Access Compliance Report

Public Rights-of-Way

Intersection ID: 43359	Main Street: WOODLAND COMMONS DR	Cross Street: RIDGEVIEW COMMONS DR	Location: W
ADA ID: F8A95519E8B5	Ramp Type: BlendTrans1	Initial Pass/Fail: Pass	Overall Compliance: No
			Severity Score: 15

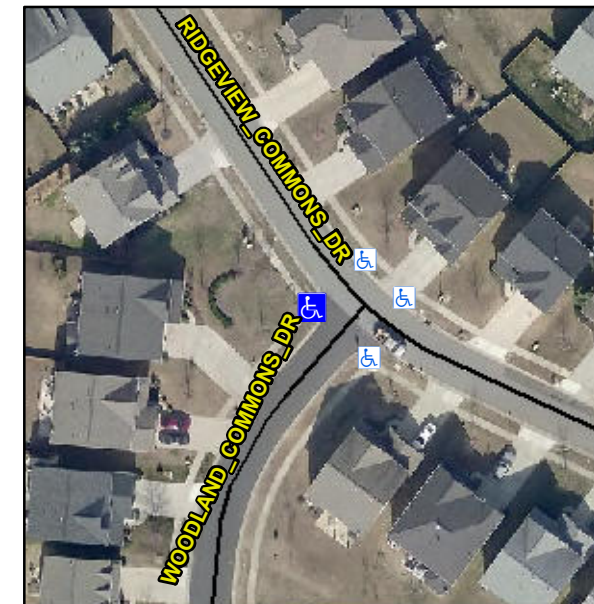
Not Found, R304.2.1, R304.5.3, R305.2, R302.7.2

N/A	Ramp inside XWalk1?	N/A	N/A	Ramp inside XWalk2?	N/A
	Road Slope (%)	1.6		Clear Space?	Yes
	Road X Slope (%)	1.7	N/A	Clear Space to XWalk (in)	N/A
Yes	Any Obstructions?	No	Yes	Storm Grate/Utility Hazard?	No
	Obstruction Type			Storm Grate/Utility Type	
		N/A			N/A
			Yes	Surface Condition? (G/P)	Good
			No	Curb Slope (%)	17.1

Remove & Replace Curb Ramp With Two New Directional Ramps or Equivalent.
